UNITED STATES PATENT AND TRADEMARK OFFICE

APPLICATION NO.	FILING DATE	FIRST NAMED INVENTOR	ATTORNEY DOCKET NO.	CONFIRMATION NO.
10/575,090	04/10/2006	Munctaka Watanabe	Q78083	8720

Office Action Summary	Application No. 10/575,090	Applicant(s) WATANABE, MUNETAKA	
	Examiner Andrés López-Esquerro	Art Unit 2818

DETAILED ACTION

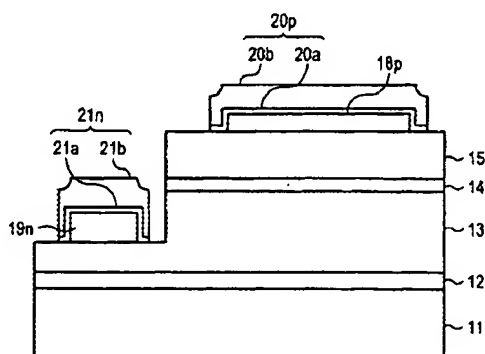
4. As for claims 1 and 14, Uemura discloses and shows in Fig. a gallium nitride base semiconductor light emitting device (LED) of the flip chip type comprising:

a. a substrate (11);

- b. an n-type semiconductor layer (13);
 - c. a light-emitting layer (14);
 - d. a p-type semiconductor layer (15);
 - e. a negative electrode (19n,21n) provided on the n-type semiconductor layer, and;

- f. a positive electrode (18p,20p) provided on the p-type semiconductor layer, comprising:
 - i. an ohmic electrode (18p);
 - ii. an adhesion (20a), and;

- iii. a bonding pad layer (20b).
5. For the limitation of "melting point of these layers being lowered in this order" are inherently present since these are characteristic of the materials used, which are, the same as claimed and therefore inherently the same properties are present in the device.
